548 Broadway Mechanical Repairs

ADDENDUM NO. 3

Project# MUN-27-41 548 Broadway Mechanical Repairs

1 DUCTWORK THROUGH DOORWAY DETAIL
SCALE: NONE

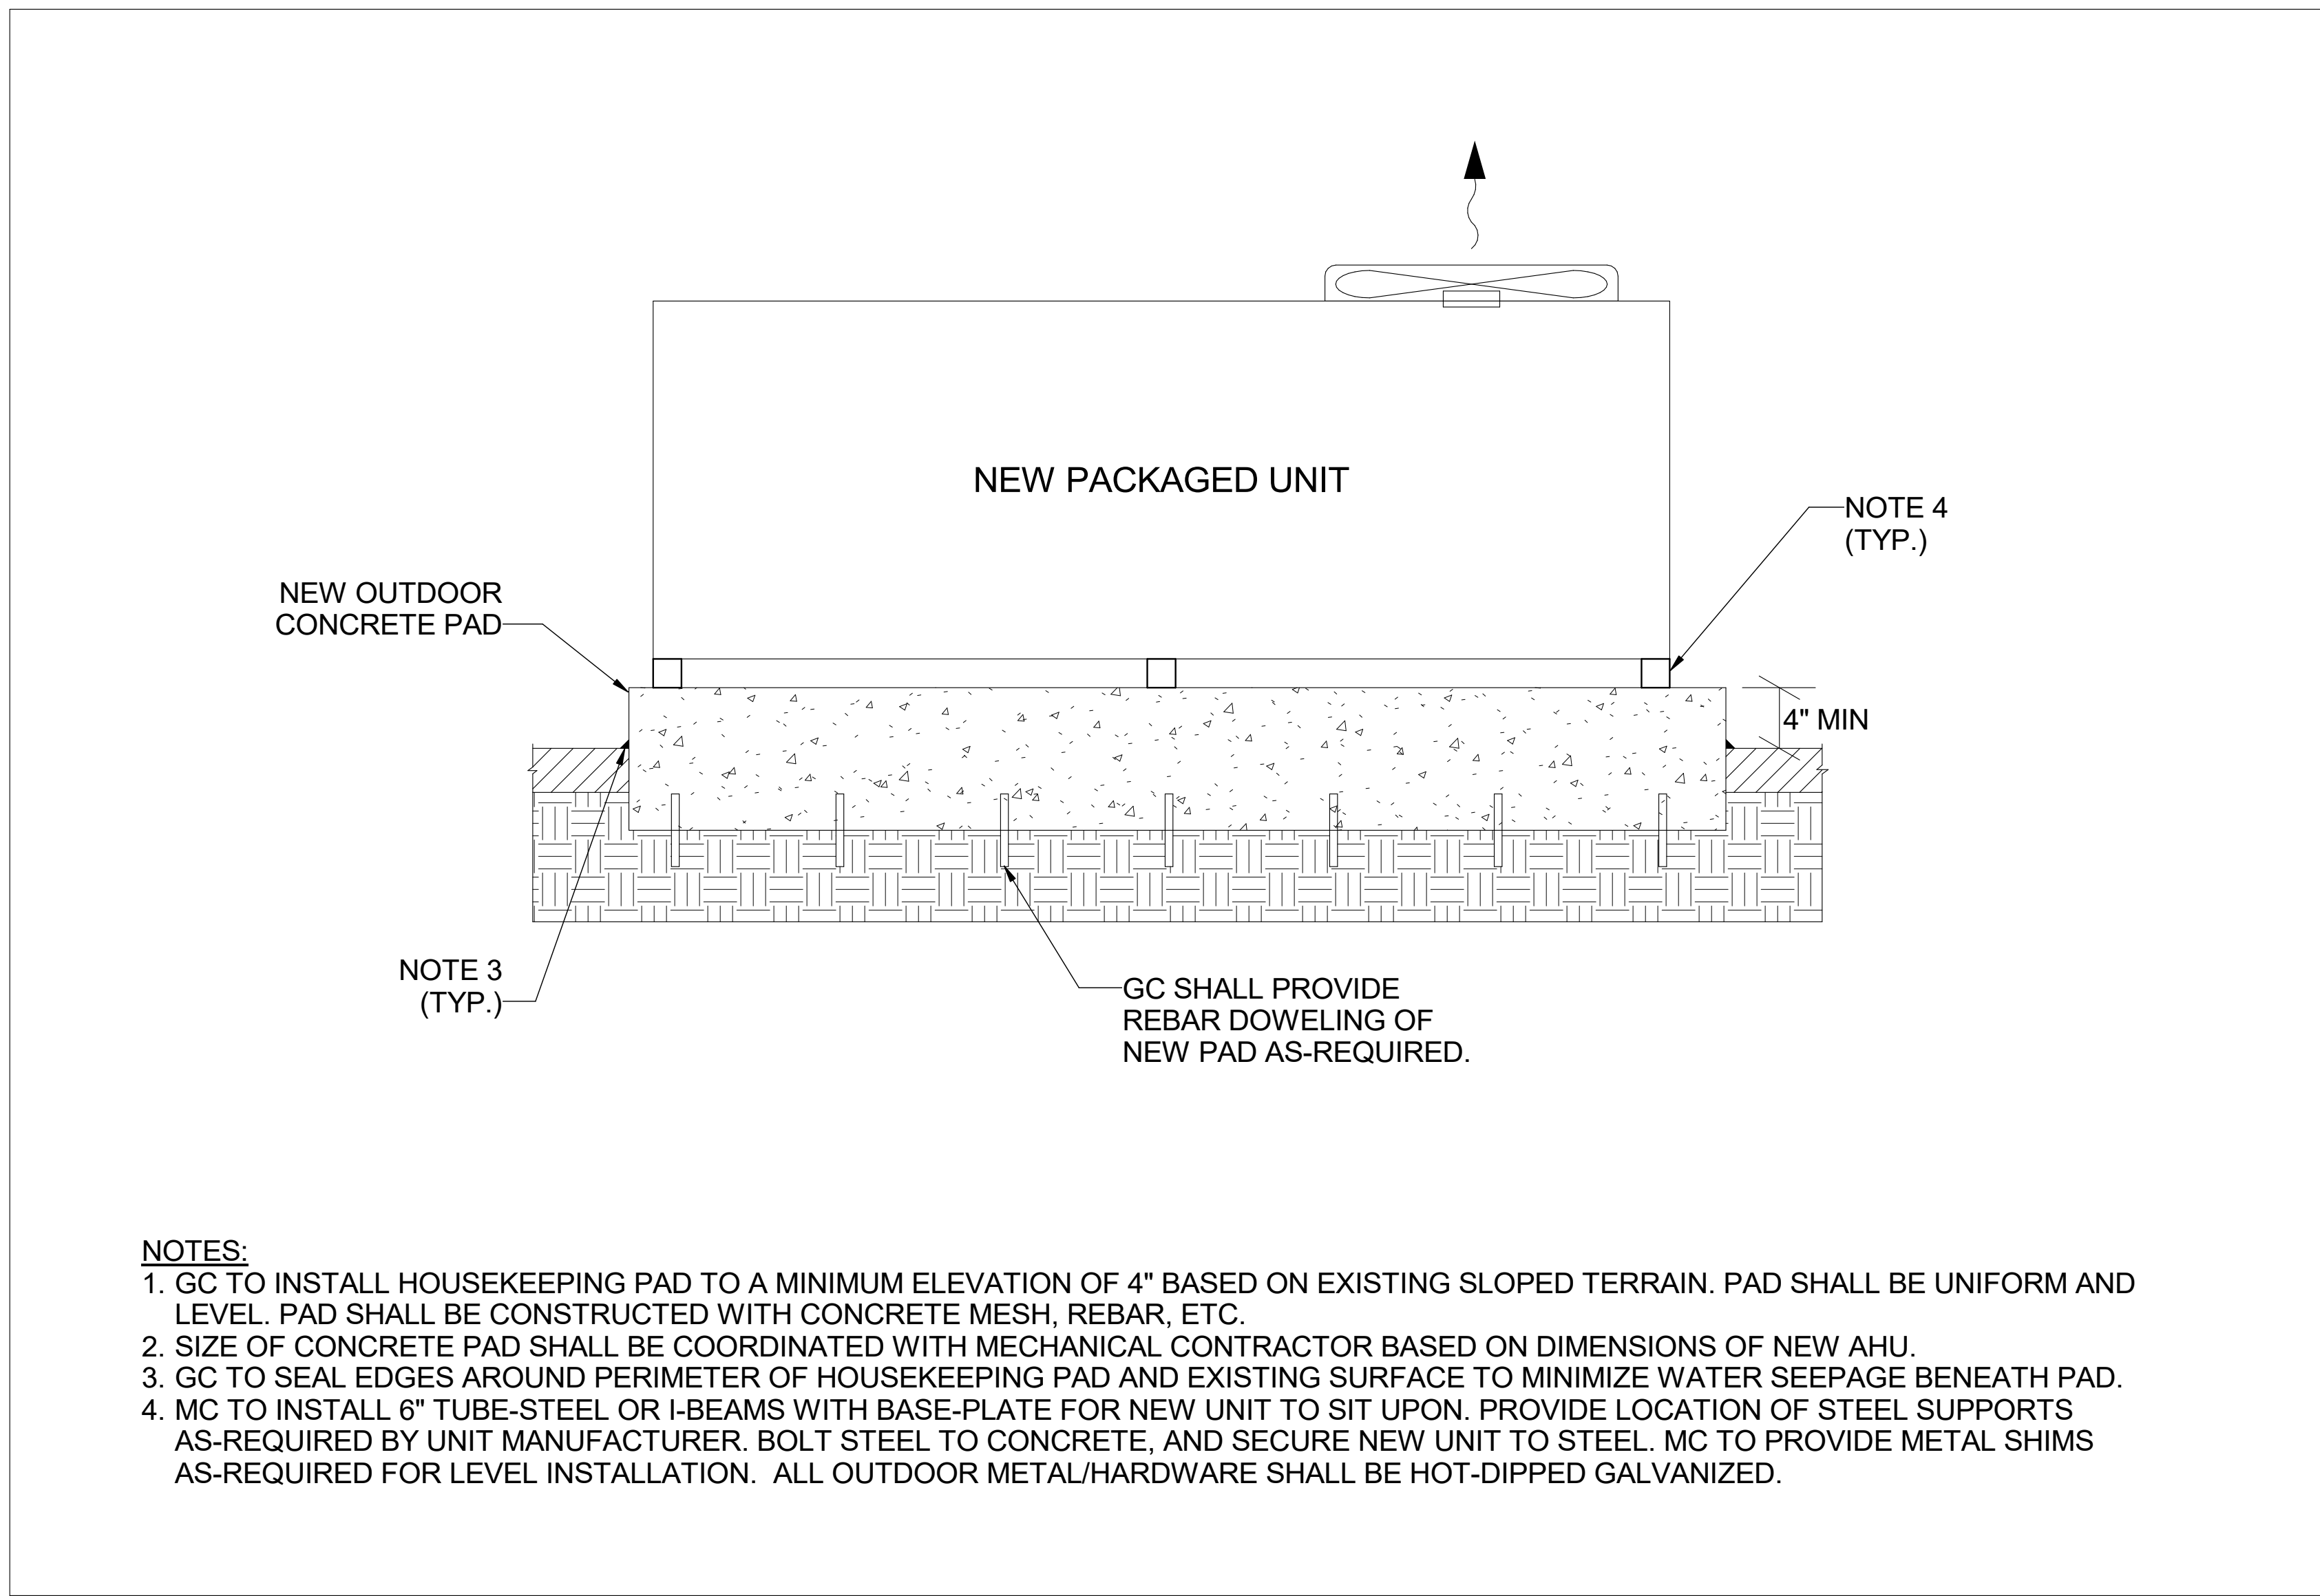
1. Question: Please provide a specification for exterior duct insulation. Spec provided appears to apply to interior duct only.
1. Answer: Outdoor duct shall be traditional sheet metal ductwork, with a weather protective insulation wrap/barrier similar to ThermaDuct or PolyGuard type system.
2. Question: With respect to duct cleaning. Note requires we clean all existing supply and return ducts that will remain. There are no plans provided for the existing systems. Please provide complete existing system drawings so it can be quantified. Alternatively, we suggest an allowance be provided for all bidders to include.
